BOARD OF TRUSTEES
REGULAR MEETING AGENDA

September 12, 2018
7:00 PM
151 Grant Avenue
Firestone, CO 80520

- 8.a. Proposed Final Plat and Final Development Plan for Cottonwood Hollow, F1
Resolution 18-31: A RESOLUTION APPROVING A FINAL PLAT AND FINAL DEVELOPMENT PLAN FOR COTTONWOOD HOLLOW, FILING 1
- 8.b. Proposed Revised Final Development Plan for Phase 2 of Gateway North-Multi Family
RESOLUTION 18-33: A RESOLUTION APPROVING A FINAL DEVELOPMENT PLAN FOR GATEWAY NORTH - MULTI-FAMILY (PHASE 2)
- 8.c. Proposed Final Plats and Final Development Plan for St Vrain Ranch Subdivision F3A and St Vrain Ranch Subdivision F5A
Resolution 18-34: A RESOLUTION APPROVING FINAL PLATS AND FINAL DEVELOPMENT PLANS FOR ST VRAIN RANCH FILINGS 3A AND 5A

FINAL DEVELOPMENT PLAN
COTTONWOOD HOLLOW, FILING 1
LOCATED IN THE NORTH HALF OF SECTION 14, TOWNSHIP 2 NORTH, RANGE 68 WEST OF THE 6TH P.M.
TOWN OF FIRESTONE, WELD COUNTY, STATE OF COLORADO
SHEET 20 OF 26

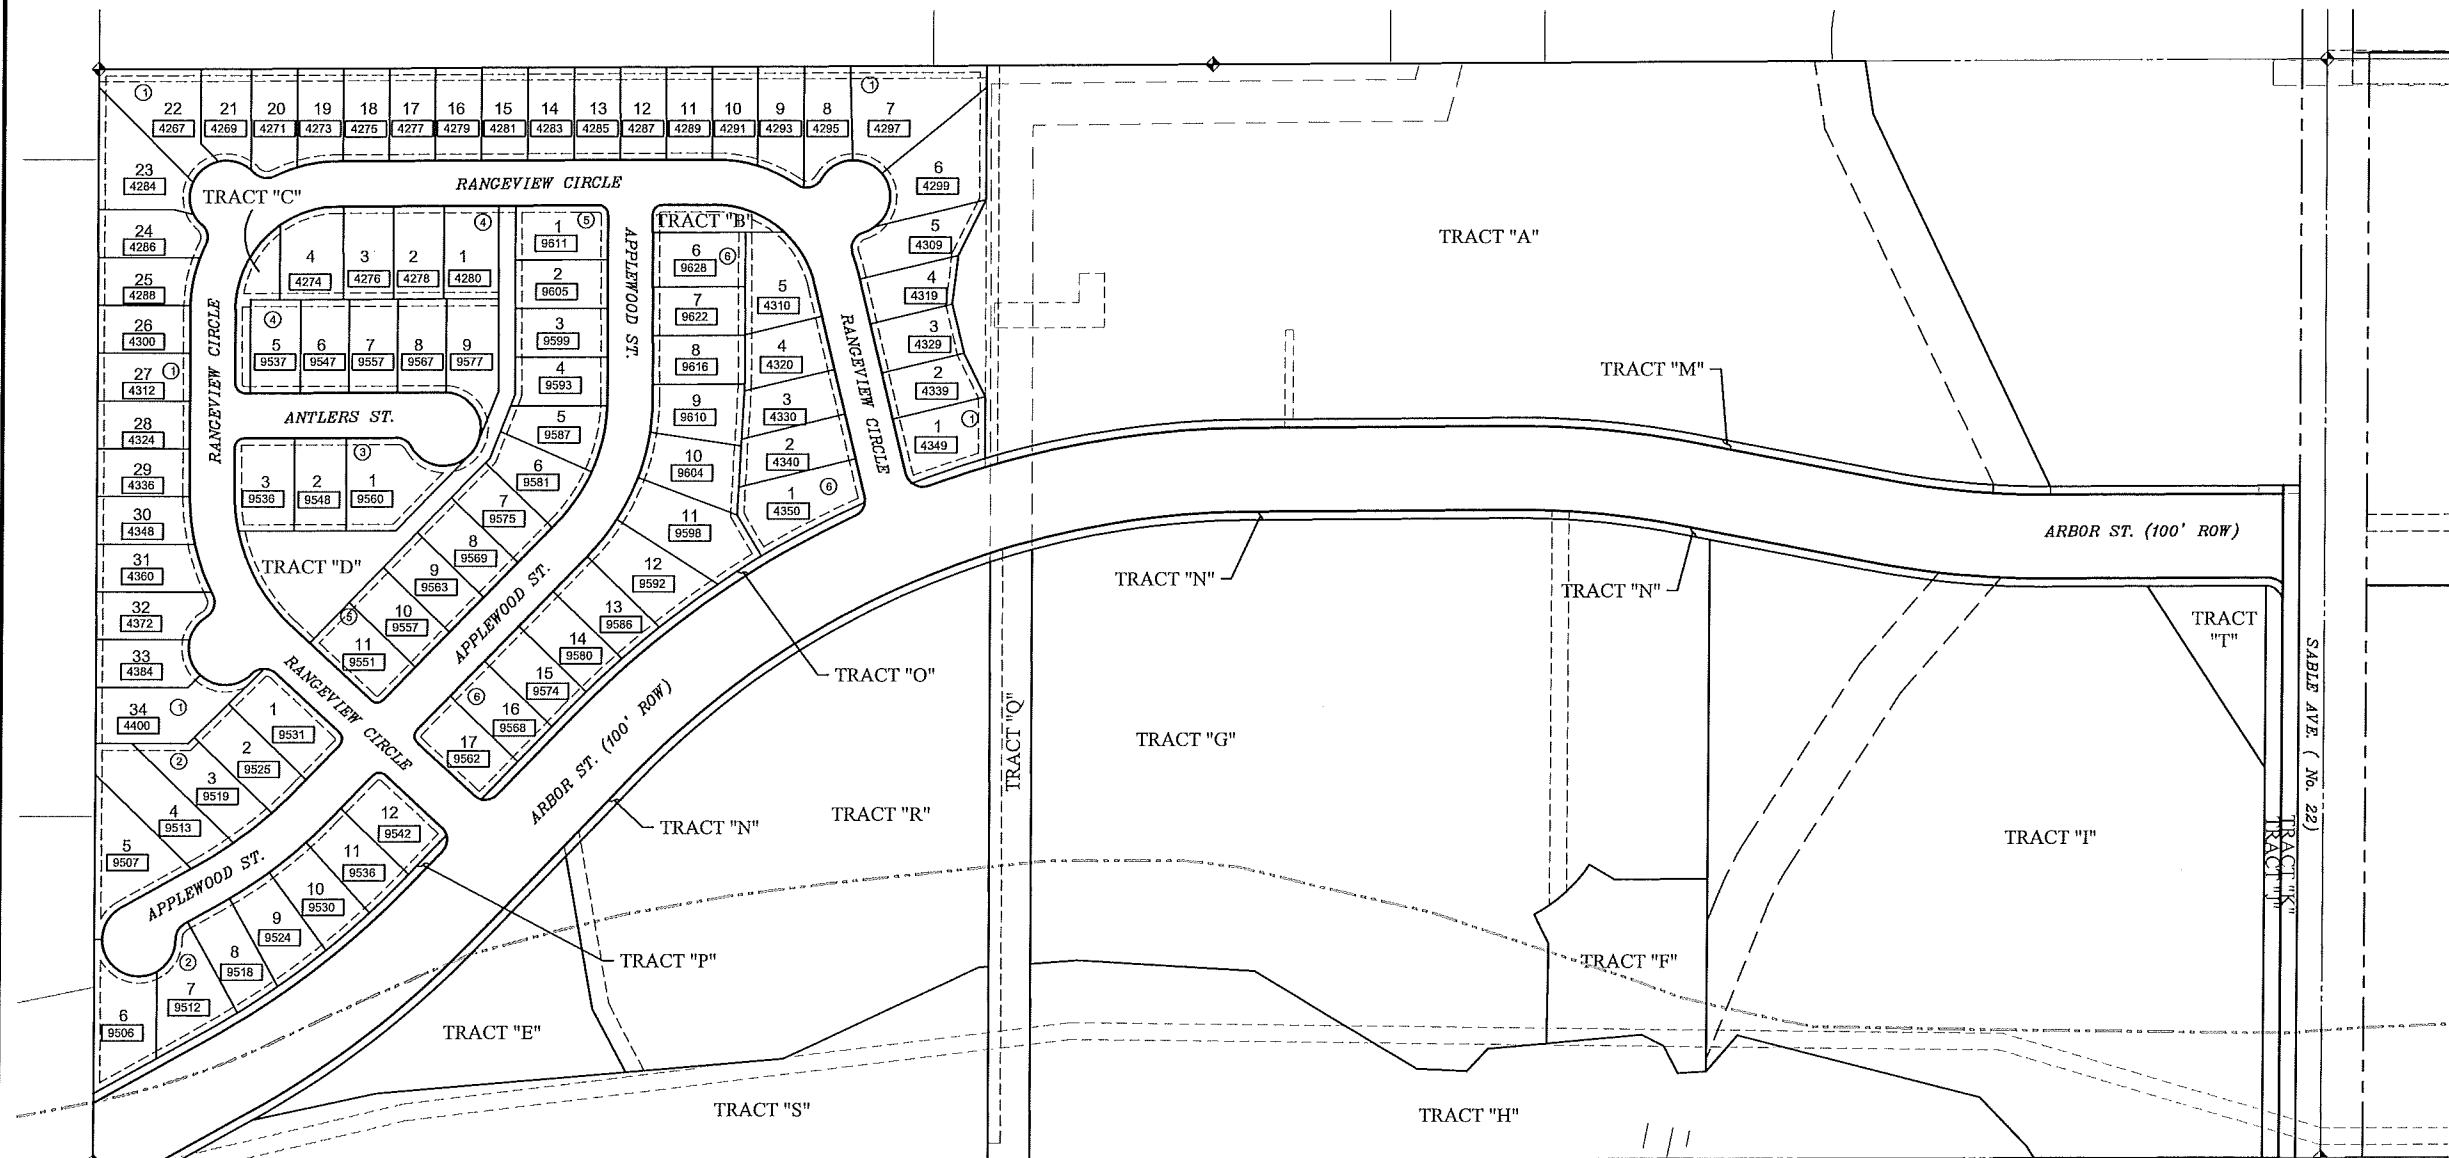
FDP Sheet 20 (Address Map)

COVER SHEET

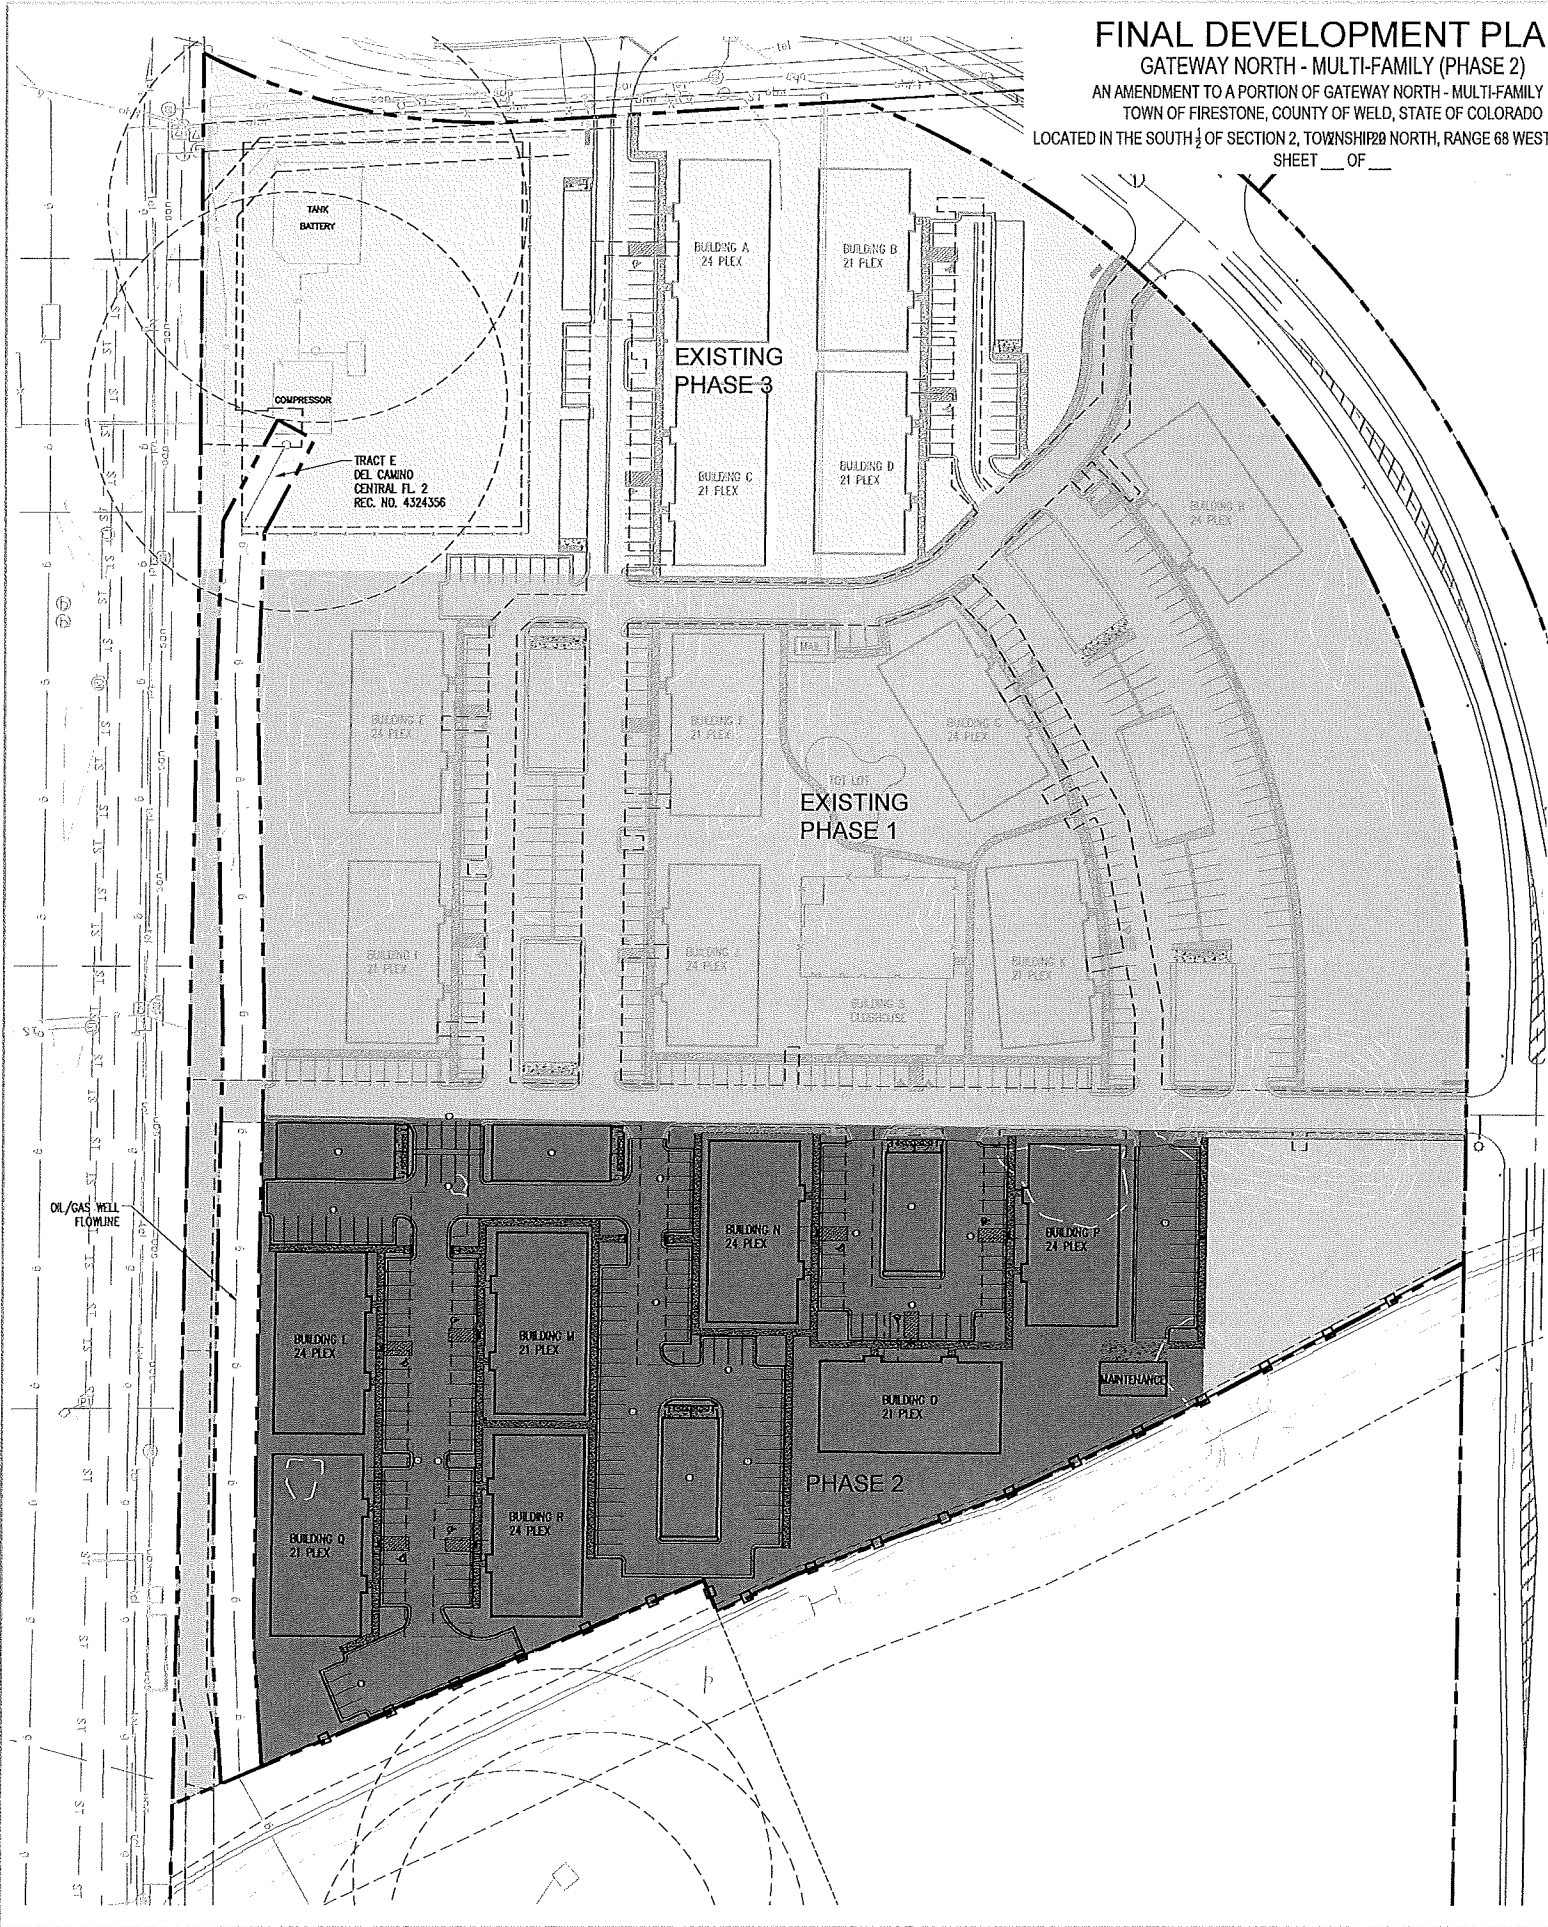
FDP Sheet 1 (Cover Sheet)

6. On all sheets (Sheets 1-20 in current submittal), revise title to read “Gateway North – Multi-Family (Phase 2).” Underneath the title, add “An Amendment to a portion of Gateway North – Multi-Family FDP.”

7. On all sheets (Sheets 1-20 in current submittal), add the phase number “2” in the Firestone Information Block.
8. Delete the third sentence of the Project Concept section (“Phases 1 and 3 are shown for illustrative purposes only.”) Revise the remaining text to reflect this is the FDP for Phase 2.

SHEET INFORMATION
PH-1.0

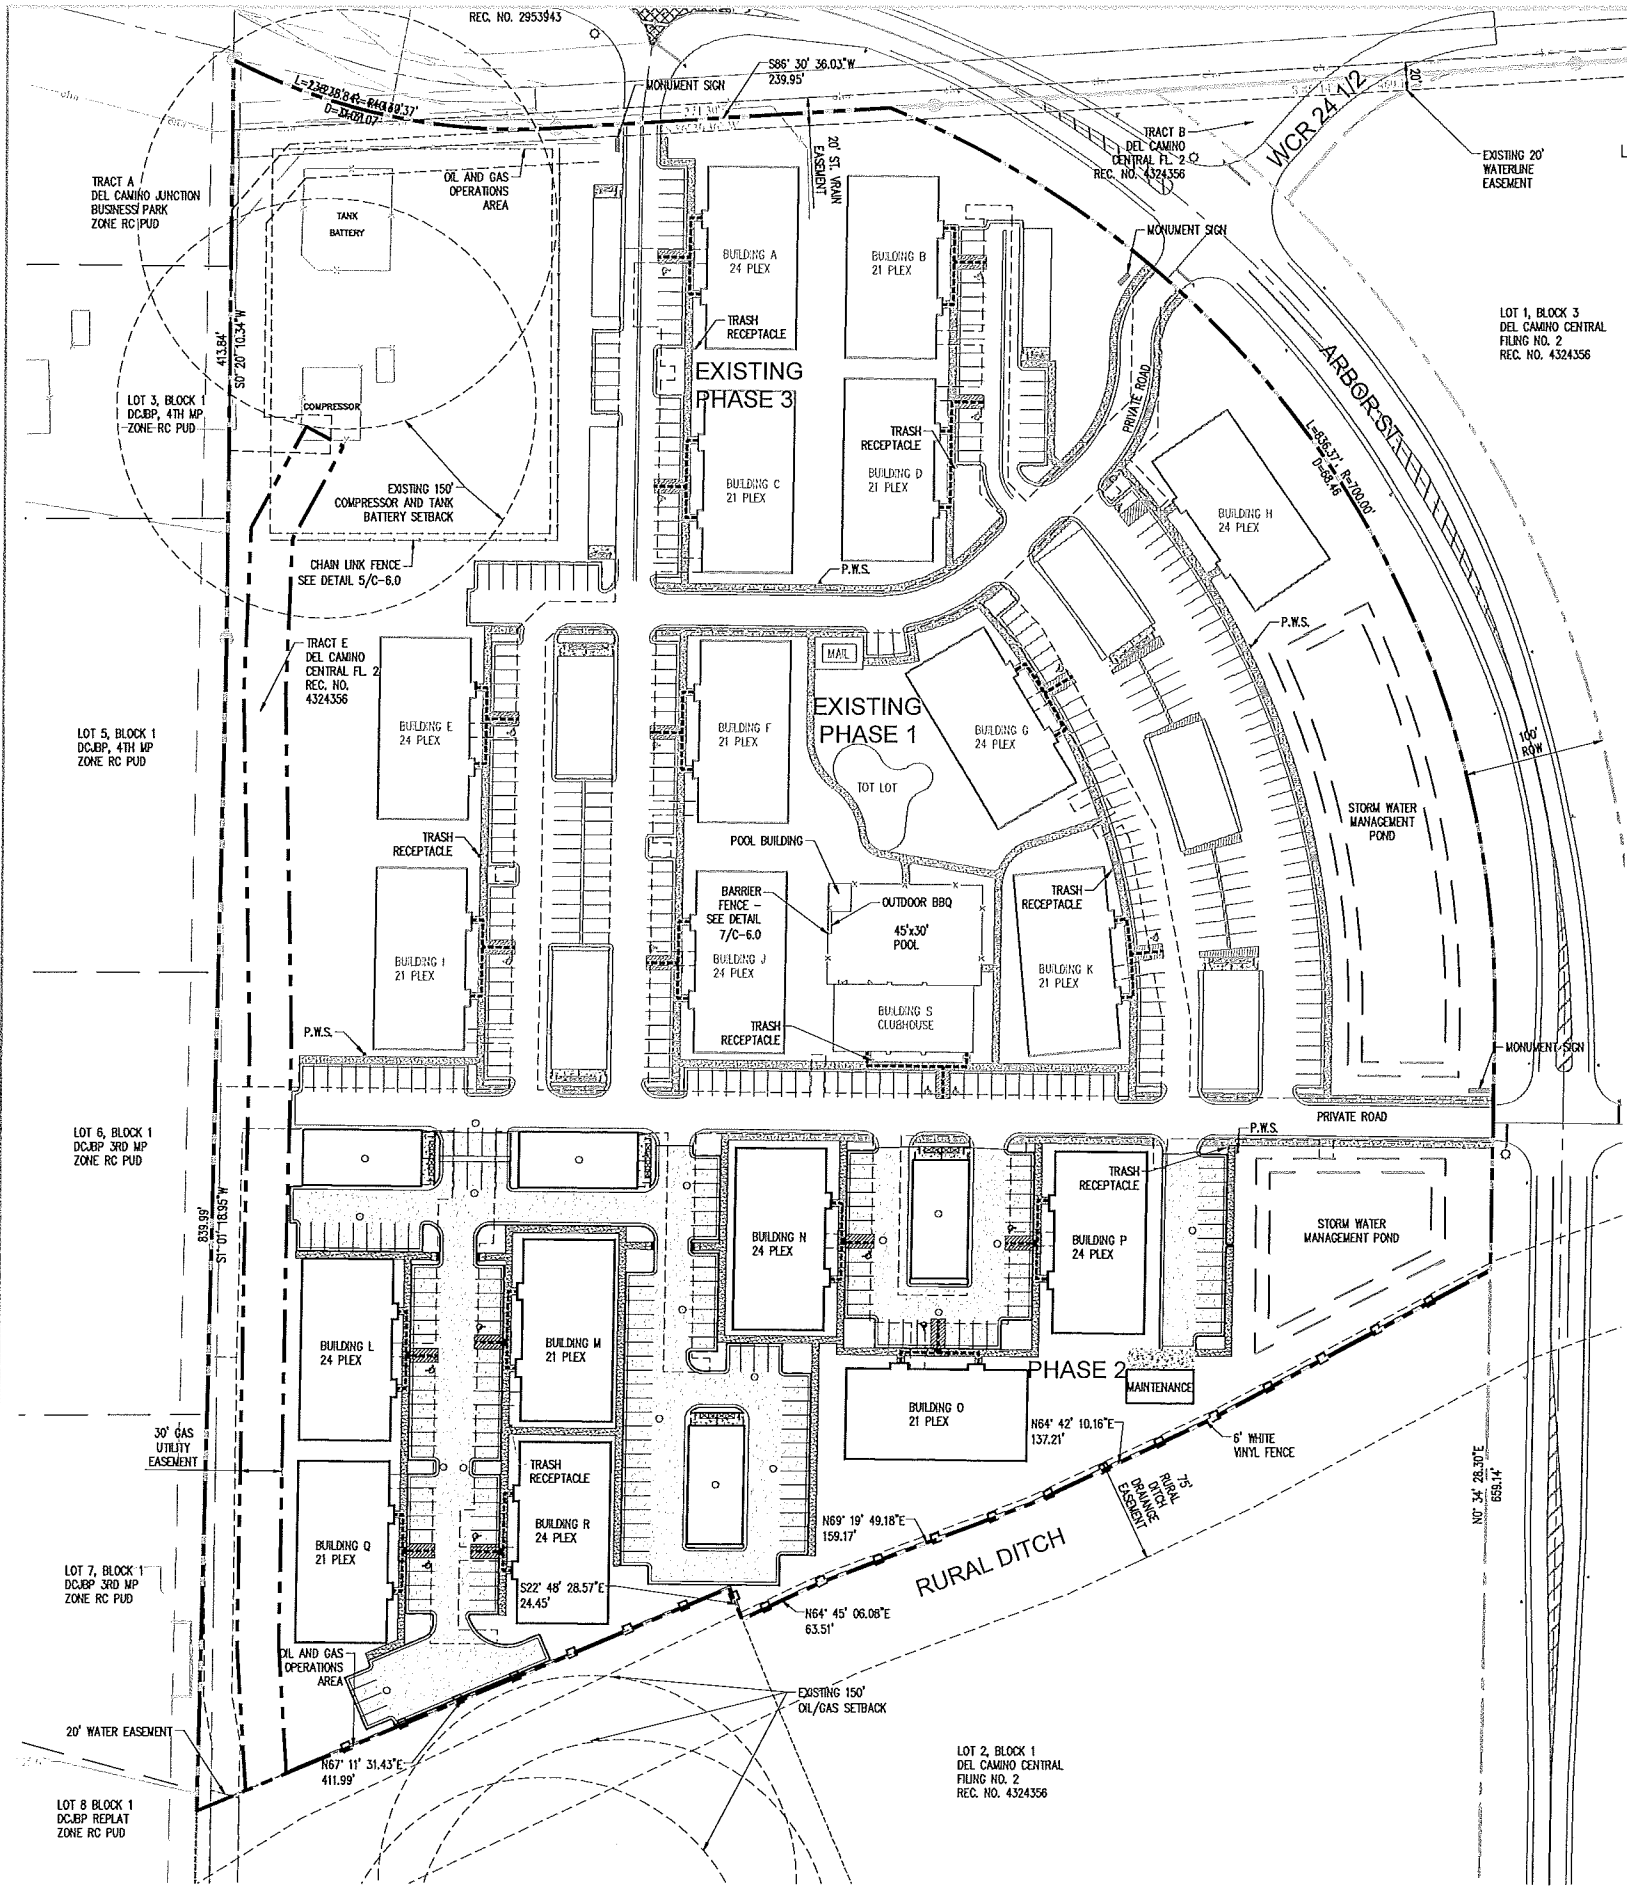
FDP Sheet 2 (Phasing Plan)

17. On all sheets showing phasing (Sheets 2-3, 5-7, 10, 13 and 14 in current submittal), add or fix the text labels “Existing Phase 3, Existing Phase 1 and Phase 2.”
18. Revise as necessary to reflect the correct site data.
